**Subject: Permit Renewal Application – Response to Technical NOD #1
Hazardous Waste Permit No. 50025
Vopak Logistics Services USA, Inc.
Vopak Logistics Services USA Deer Park
2759 Independence Parkway South, Deer Park, Texas 77536
Tracking No. 30098179, CN 601527955 / RN 100223007**

On behalf of Vopak Logistics Services USA, Inc (Vopak), EngiCon Environmental, LLC (EngiCon) has prepared this response letter to the Texas Commission on Environmental Quality (TCEQ) notice of deficiency e-mail dated December 19, 2024 regarding the Hazardous Waste Permit Renewal Application for the Vopak Logistics Services USA Deer Park facility located at 2759 Independence Parkway South, Deer Park, Texas.

**Subject: Permit Renewal Application – Response to Technical NOD #2
Hazardous Waste Permit No. 50025
Vopak Logistics Services USA, Inc.
Vopak Logistics Services USA Deer Park
2759 Independence Parkway South, Deer Park, Texas 77536
Tracking No. 30098179, CN 601527955 / RN 100223007**

Facility Layout Plan

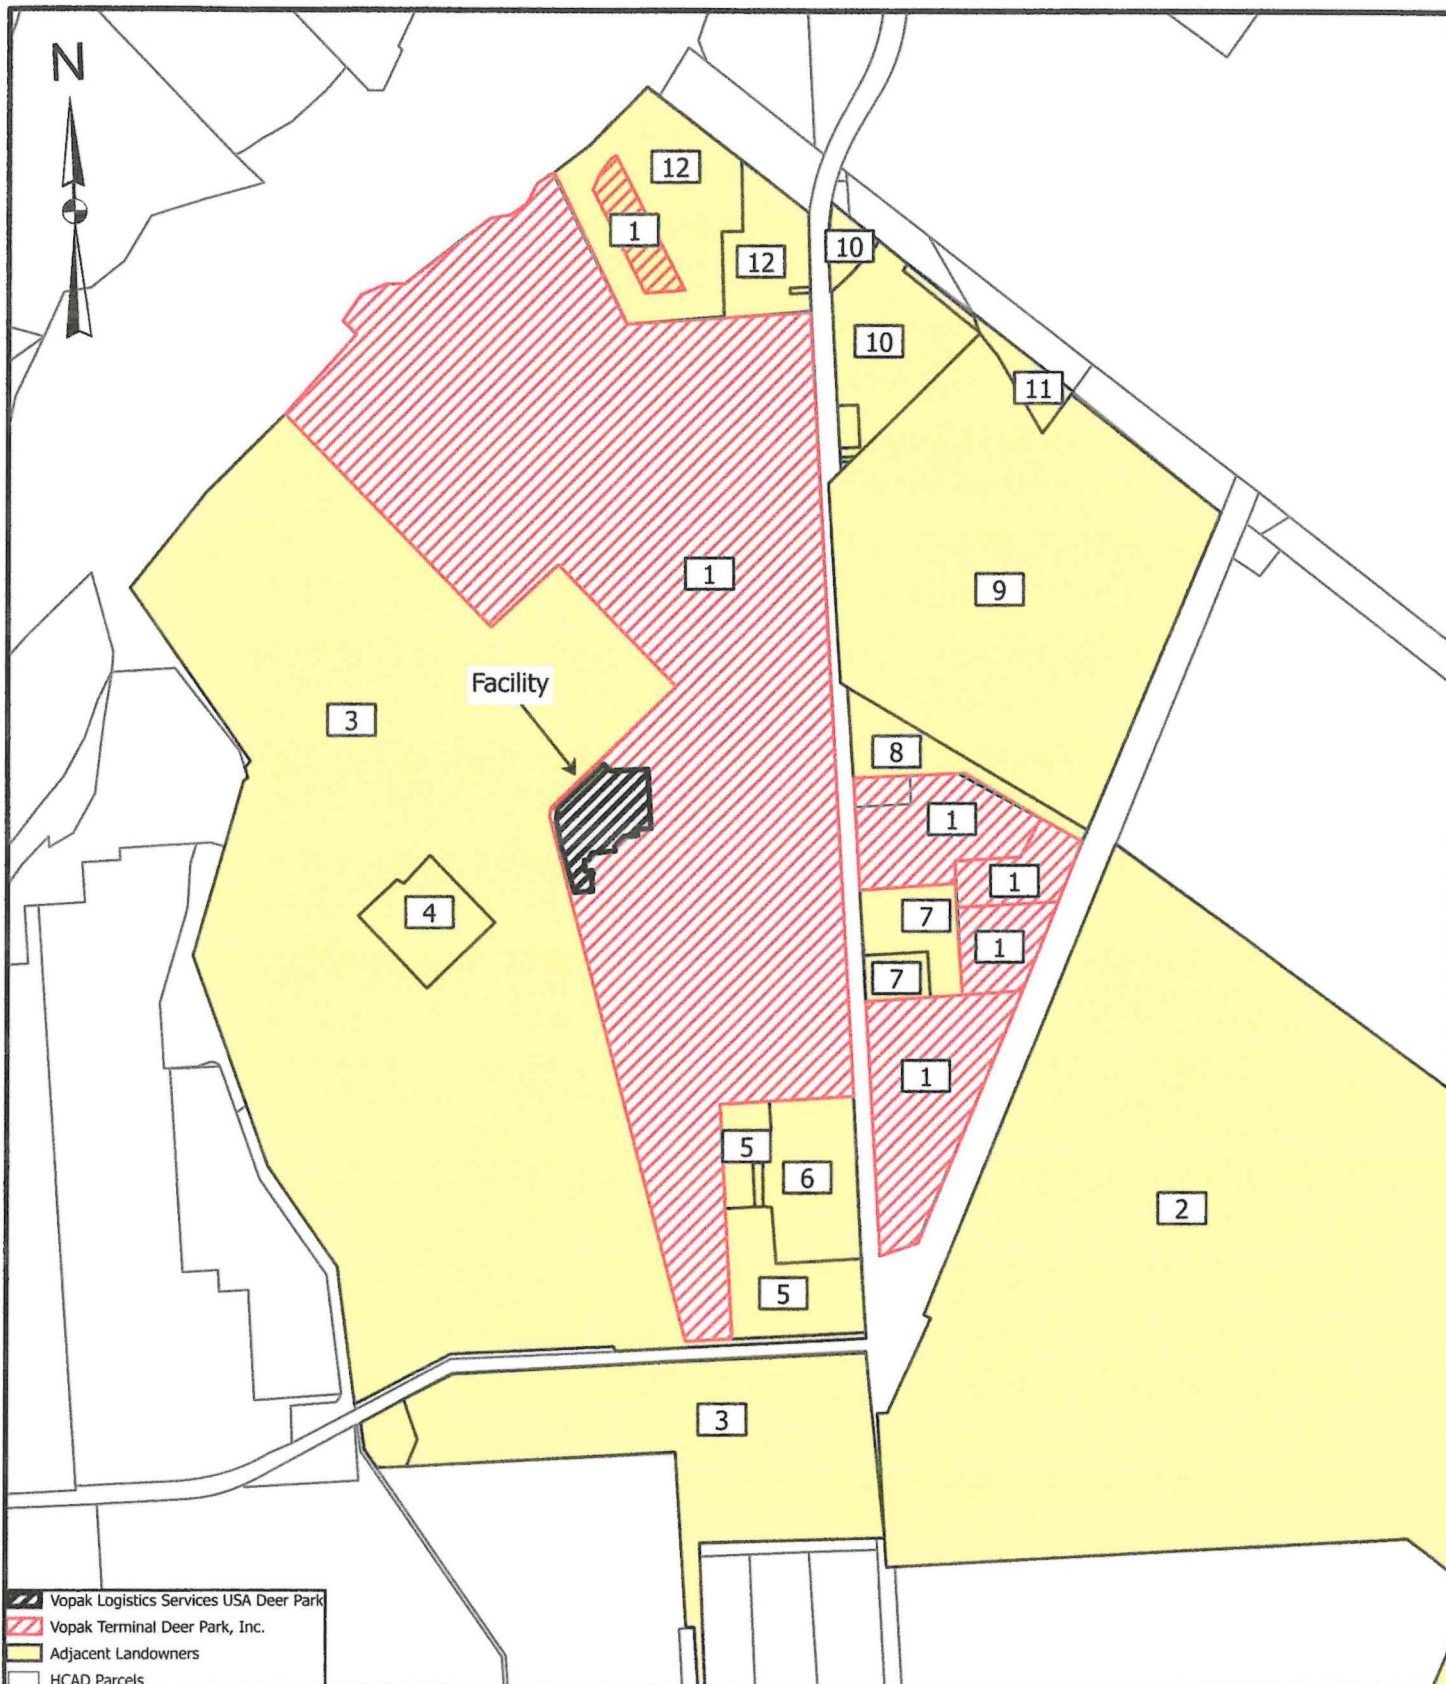
(T1) Application Part B Section V Page 220 Citation 30 TAC 305.45(a)(6)(A): Update the Facility Layout Plan to show the following HW management units: 05-T-44, 05-T-9C, 05-T-590, 05-V-1, 05-T-39, 05-T-40, 05-T-41, 05-T-42, and 05-V-2.

Response: The Facility Layout Plan is updated and attached as requested. Please note that 05-T-9C is closed, while 05-V-1 is closed and replaced by 05-V-2. Tanks 05-T-39, 05-T-40, 05-T-41, and 05-T-42 are not built.

Adjacent
Landowners Map

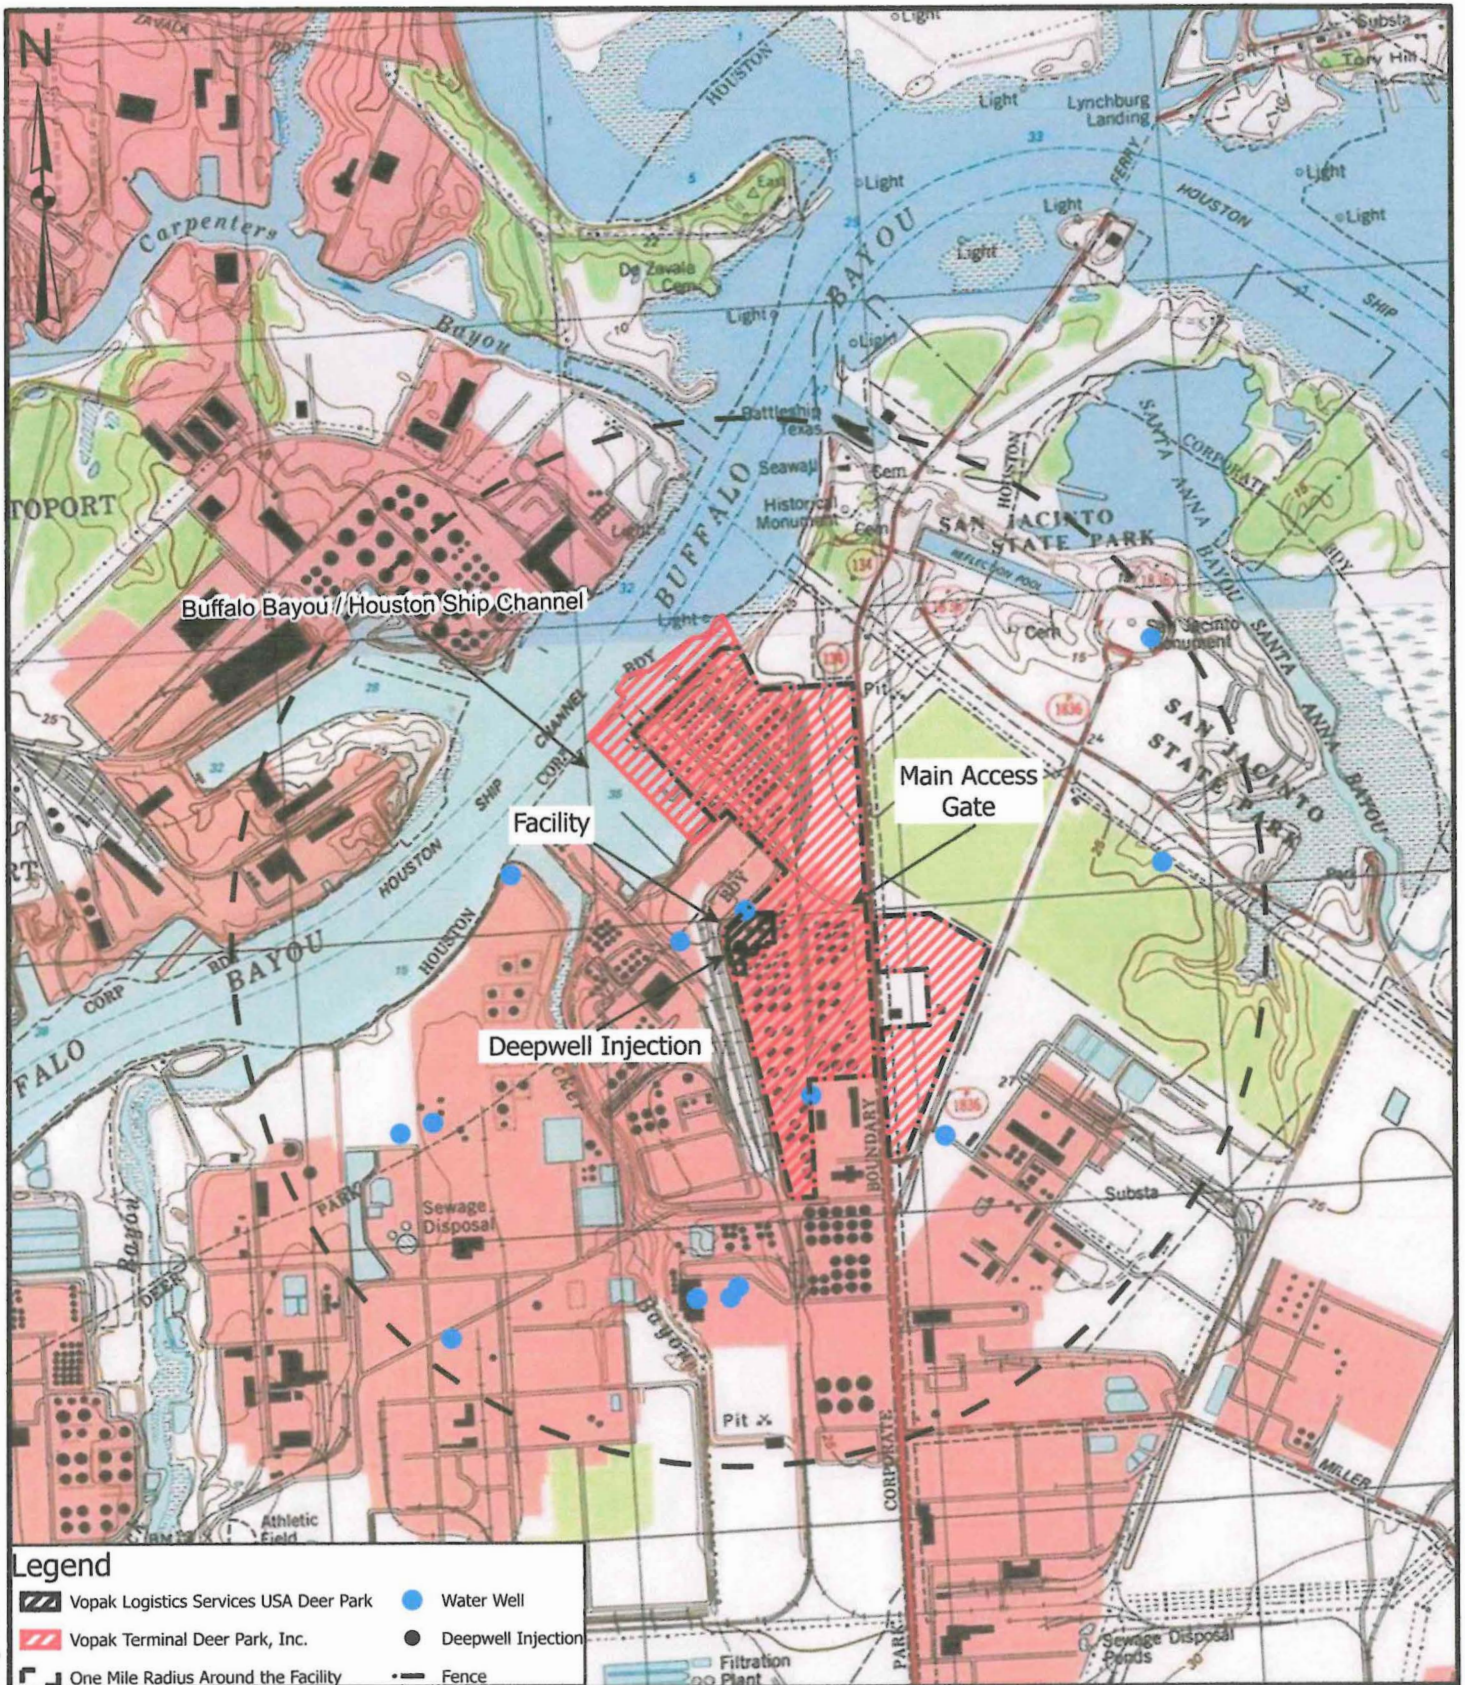
- (T2) Application Part B Section V Appendix V.A Citation 30 TAC 305.45(a)(6)(D): Provide a map showing ownership of tracts of land adjacent to facility and within reasonable distance from proposed or existing activity. If this map is included in a location different from the one shown on this row, reference this location.

Response: The Adjacent Landowners Map and list of property owners is provided in Part B Section 1 – General Information under Appendix I.E – Map and List of Adjacent Landowners Page 44 of Part B digital pdf.

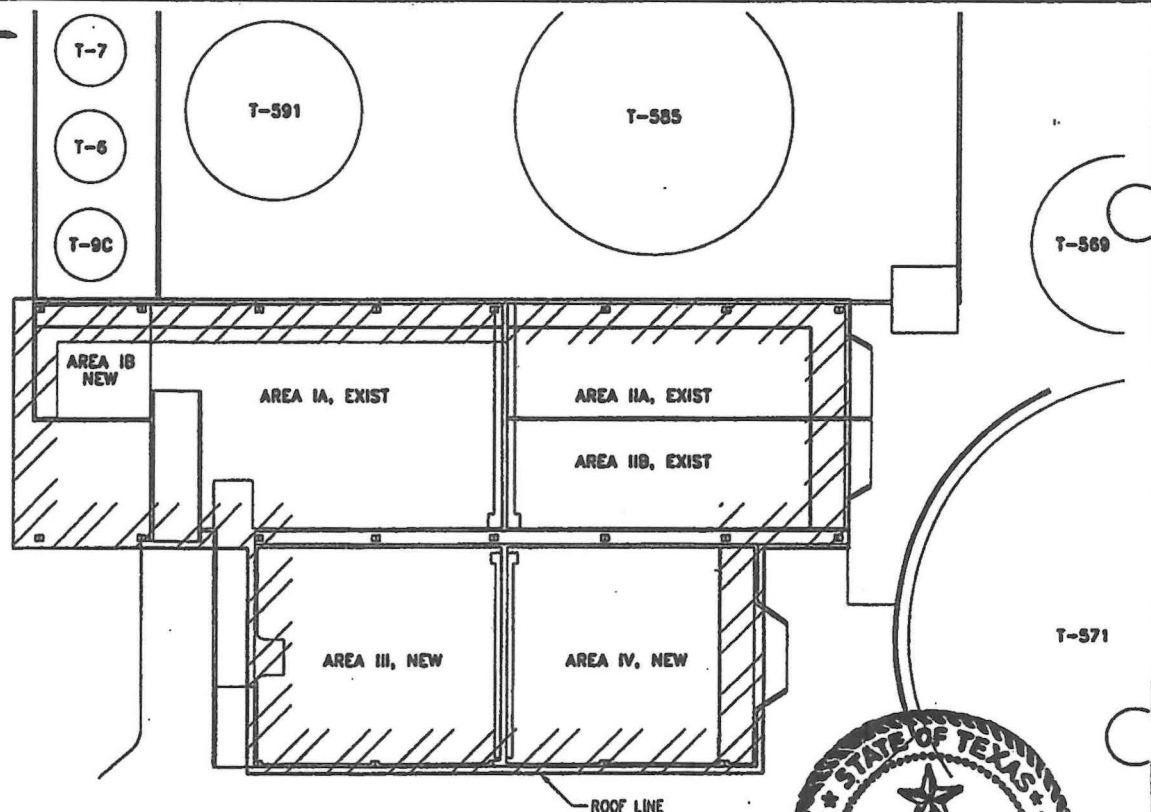
- (T4) Application Part B Section V Page 257 Citation 40 CFR 264.175(b)(3): Provide drawing 05-10-0015. It was referenced in page 257 of the pdf digital Part B application, but it was no where to be found in the document.

- (T6) Application Part B Section V Pages 212, 234 and 257 Citation 40 CFR 264.175(b): Resolve the following inconsistency with respect to protection from rainfall for the containment system of CSA 05-D-1: Pg. 212 Section 5.0 states "CSA 05-D-1 is covered". Pgs. 233 and 234 also state this CSA is covered. Pg. 257 relates that each section of this CSA is covered with a roof for partial protection from rainfall. If the CSA is only partially covered, shouldn't there be some estimation for rainfall in the CSA calculations of its secondary containment in pgs. 233 and 234?

(T9) Application Part B Section V Page 257 Citation 40 CFR 264.175(b): Provide drawing 05-10-0015 which was referenced on pg. 257 of the digital Part B application but it was not found.

Response: Drawing 05-10-0015 is attached as part of this response letter.

Response: Container Storage Area CSA 05-D-1 is covered and as shown on Drawing No. 05-10-0015. However, to account for precipitation, and based on the industry standard of the "rule of thumb" of 110% of the container capacity, the updated secondary containment calculations to include precipitation are attached.

Response: Drawing 05-10-0015 is attached as part of this submittal.

REPORTS FOR RCRA PART "B"				
SECONDARY CONTAINMENT - TANK 05-T-42				
FUELS				
NOR #86				
Sheet Size:	Location:	Job #:	Drawing Number:	Rev. #
B		760-EM	05-10-0007	1

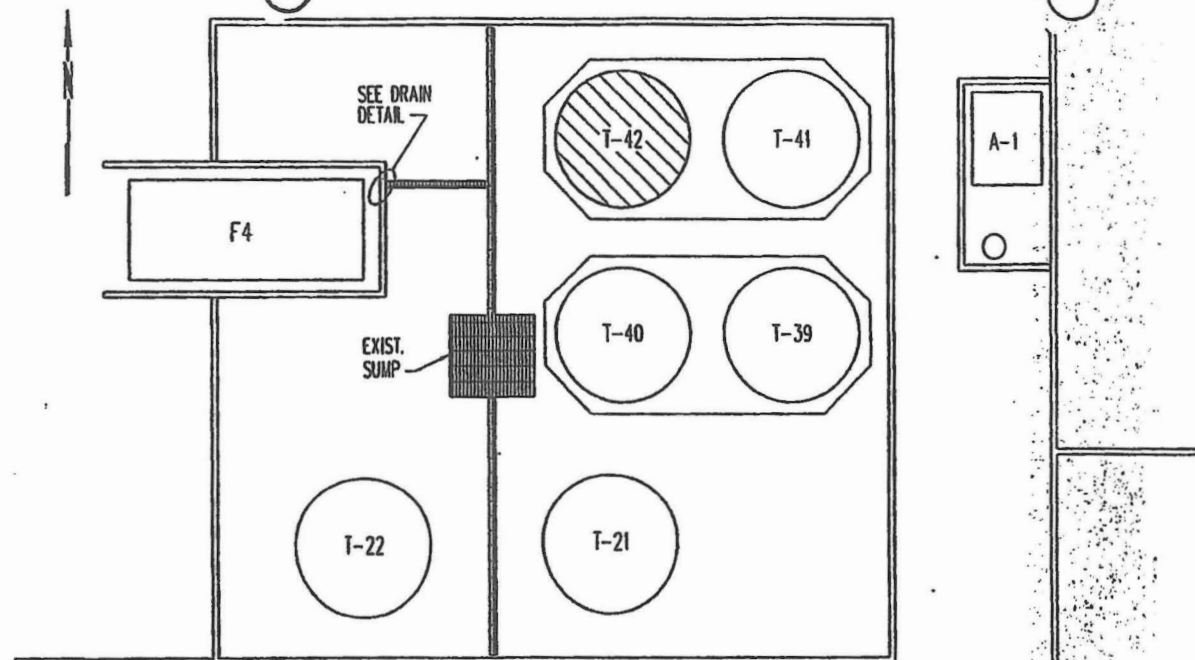
(T20) Application Part B Section V Page 335 Citation 40 CFR 264.193(e)(1)(iii): Update Tank 05-T-42 Drawing 05-10-0007 to show the most current rainfall precipitation data. The rainfall data in this drawing appears to be from 2001, when it was P.E. stamped.

Response: Tank 05-T-42 is permitted under TCEQ Permit Unit No. 67 based on the original engineering design, and using the acceptable rainfall precipitation data based on the Rainfall Frequency Atlas of the United States, Technical Paper 40, dated January 1963. Any future hazardous waste management units will be permitted based on the most up-to-date rainfall precipitation, and based on good engineering practice.

For the secondary containment calculations, refer to the Emulsified Oil Treatment System (EOTS) – Proposed: Secondary Containment Calculations. Drawing No. 05-10-0007 is provided for historical reference.

REPORTS FOR RCRA PART "B"				
SECONDARY CONTAINMENT - TANK 05-T-41				
FUELS				
NOR #85				
Sheet Size:	Location:	Job #:	Drawing Number:	Rev. #
B		760-EM	05-10-0006	1

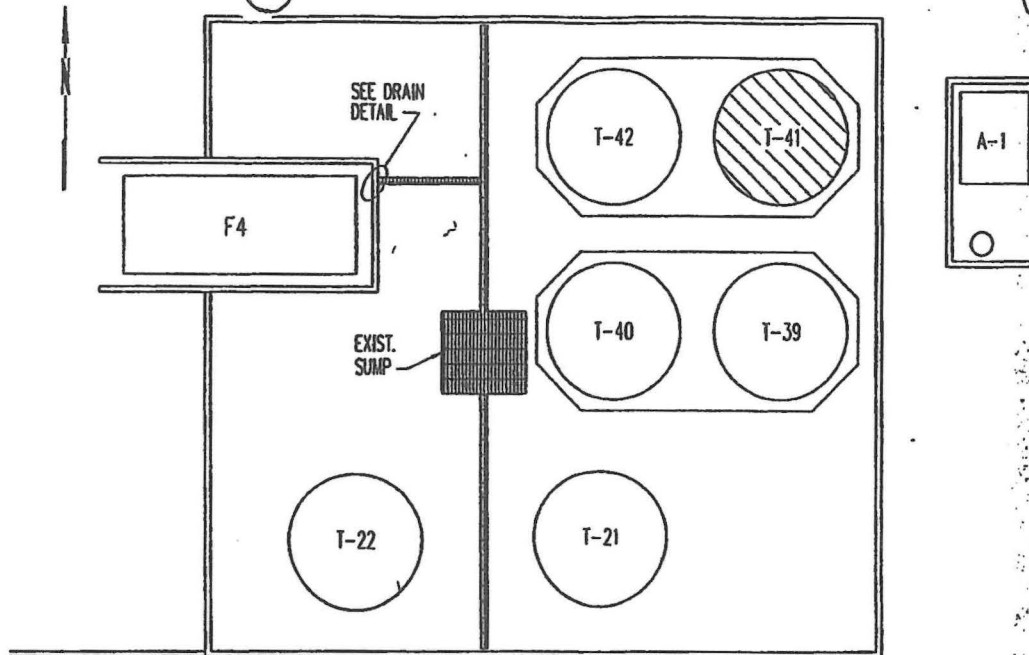
(T19) Application Part B Section V Page 332 Citation 40 CFR 264.193(e)(1)(iii): Update Tank 05-T-41 Drawing 05-10-0006 to show the most current rainfall precipitation data. The rainfall data in this drawing appears to be from 2001, when it was P.E. stamped.

Response: Tank 05-T-41 is permitted under TCEQ Permit Unit No. 67 based on the original engineering design, and using the acceptable rainfall precipitation data based on the Rainfall Frequency Atlas of the United States, Technical Paper 40, dated January 1963. Any future hazardous waste management units will be permitted based on the most up-to-date rainfall precipitation, and based on good engineering practice.

For the secondary containment calculations, refer to the Emulsified Oil Treatment System (EOTS) – Proposed: Secondary Containment Calculations. Drawing No. 05-10-0006 is provided for historical reference.

REPORTS FOR RCRA PART "B"				
SECONDARY CONTAINMENT - TANK 05-T-40				
EOTS				
NOR #84	Sheet Size:	Location:	Job #:	Drawing Number:
B			760-EM	05-10-0005
				Rev. #
				1

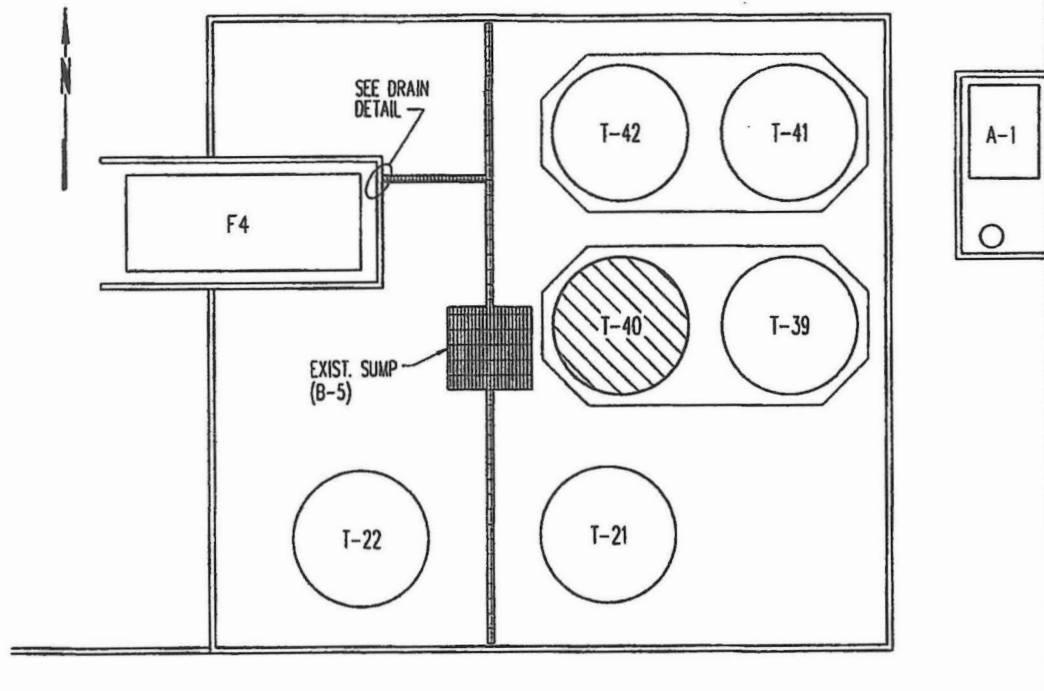
(T13) Application Part B Section V Page 302 Citation 40 CFR 264.193(e)(1)(iii): Update Tank 05-T-40 Drawing 05-10-0005 to show the most current rainfall precipitation data. The rainfall data in this drawing appears to be from 2001, when it was P.E. stamped.

Response: Tank 05-T-40 is permitted under TCEQ Permit Unit No. 66 based on the original engineering design, and using the acceptable rainfall precipitation data based on the Rainfall Frequency Atlas of the United States, Technical Paper 40, dated January 1963. Any future hazardous waste management units will be permitted based on the most up-to-date rainfall precipitation, and based on good engineering practice.

For the secondary containment calculations, refer to the Emulsified Oil Treatment System (EOTS) – Proposed: Secondary Containment Calculations. Drawing No. 05-10-0005 is provided for historical reference.

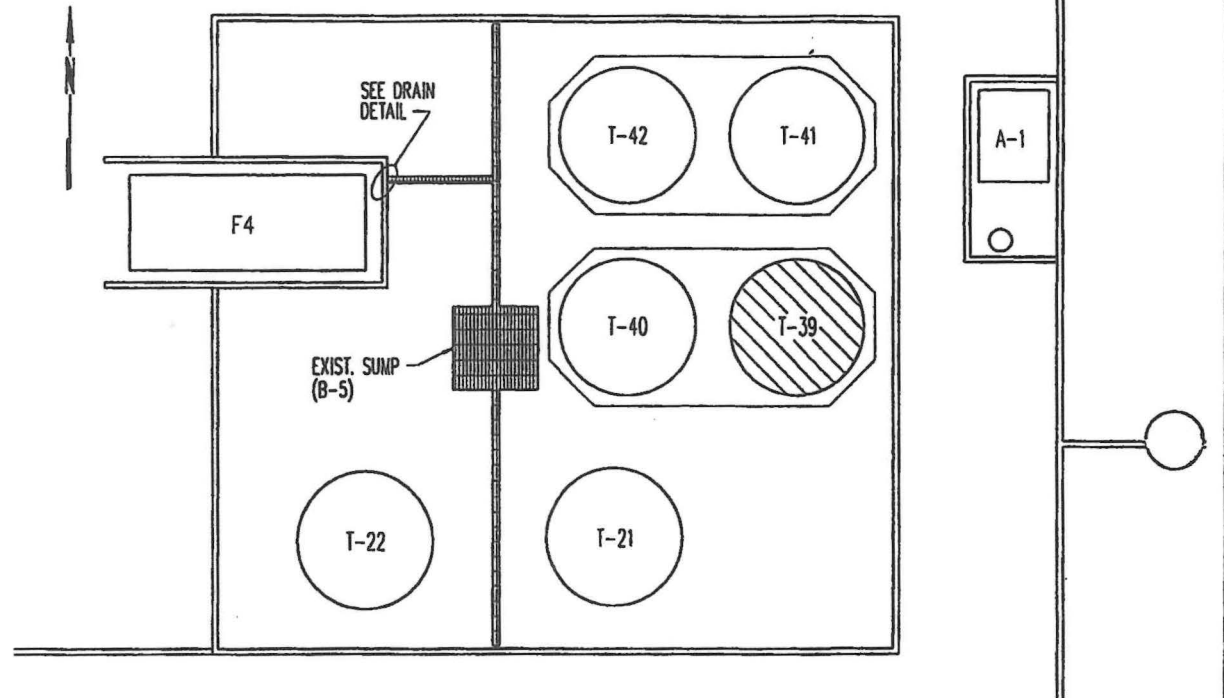
(T12) Application Part B Section V Page 299 Citation 40 CFR 264.193(e)(1)(iii): Update Tank 05-T-39 Drawing 05-10-0004 to show the most current rainfall precipitation data. The rainfall data in this drawing appears to be from 2001, when it was P.E. stamped.

Response: Tank 05-T-39 is permitted under TCEQ Permit Unit No. 65 based on the original engineering design, and using the acceptable rainfall precipitation data based on the Rainfall Frequency Atlas of the United

States, Technical Paper 40, dated January 1963. Any future hazardous waste management units will be permitted based on the most up-to-date rainfall precipitation, and based on good engineering practice.

For the secondary containment calculations, refer to the Emulsified Oil Treatment System (EOTS) – Proposed: Secondary Containment Calculations. Drawing No. 05-10-0004 is provided for historical reference.
